# ***TPS EXPRESS NEWSLETTER***

The **NEWSLETTER** provides requirements updates and changes to the 27 August 2009 baseline. Some requirements should be “immediately” incorporated in existing contracts, taking into account cost and schedule impact. Not incorporating them will cause the Navy to retrofit the TPS after contract acceptance.

## **10-08 PANEL MOUNTED RF CONNECTORS**

## **10-09 PACKAGING OF SMALL ANCILLARY ITEMS**

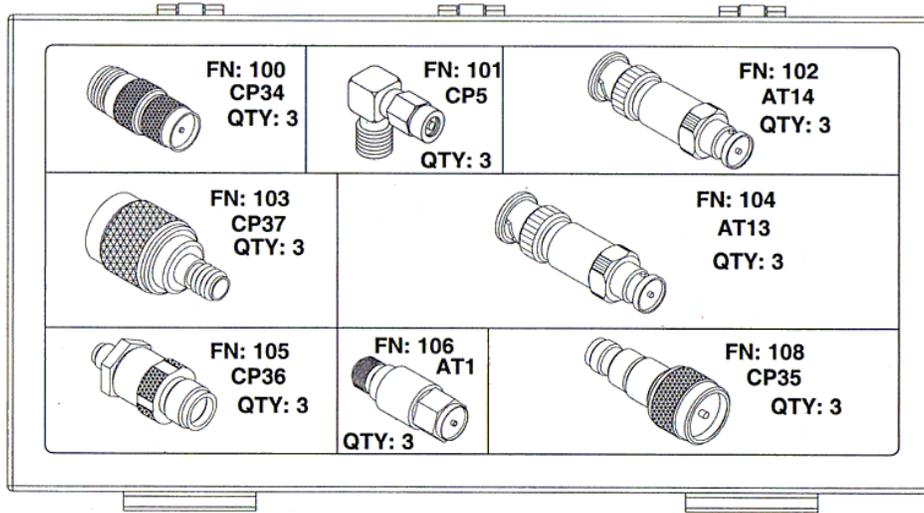
**CONTRACT SECTION D - PACKAGING AND MARKING, modify paragraph as shown below:**

Items 0001 and Option Item 0101 - All supplies, except accessories, to be furnished hereunder shall be preserved, packaged, and packed in accordance with ASTM D 3951-95, Standard Practice for Commercial Packaging. ~~Accessories shall be packaged in a durable storage case. The items shall be stored in such a manner to facilitate visual inventory (e.g. foam cut-outs).~~

All cable sets shall be stored in circular, padded, zippered cable bags for each OTPS. The cable set bags shall be clearly identified.

Small OTPH Accessories (e.g. BNC connectors, SMA connectors) shall be packaged in clear storage case (e.g. tackle box). Identify the OTPH nomenclature on the exterior of the case. Display the physical location of the parts by photograph/graphics, quantity and nomenclature on the inside lid of the case. See example below.
